# Access Compliance Report Public Rights-of-Way (Curb Ramps)

Main Street: EPONA\_WAY Cross Street: NARROW\_CANYON\_RD Location: W

ADA ID: RPRK211027143505 Ramp Type: Type 4 - Parallel Initial Pass/Fail: Pass Overall Compliance: No Severity Score: 25

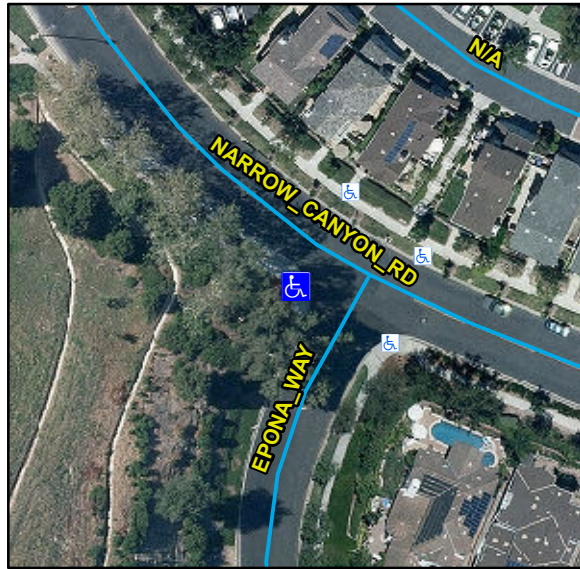
R304.2.2, R204.3, R304.2.1, R304.2.2-Perp, R304.3.2-Para, R304.5.3, R305, R304.5.4, STD 1115

| Compliance | Description                   | Data       | Compliance | Description                   | Data |
|------------|-------------------------------|------------|------------|-------------------------------|------|
| N/A        | Landing Present               | No         | No         | DWS Provided                  | No   |
| No         | Landing Width (in)            | N/A        | N/A        | DWS Length (in)               | N/A  |
| No         | Landing Run Slope (%)         | N/A        | N/A        | DWS Full Width                | N/A  |
| No         | Landing Cross Slope (%)       | N/A        |            | DWS Offset Type               | N/A  |
| Yes        | Gutter Ponding                | No         | No         | Curb Slope                    | 12.1 |
| No         | Gutter Run Slope (%)          | 10.3       |            | Road Cross Slope (%)          | 0.1  |

Remove & Replace Curb Ramp With Two New Directional Ramps or Equivalent. Remove & Replace Gutter.
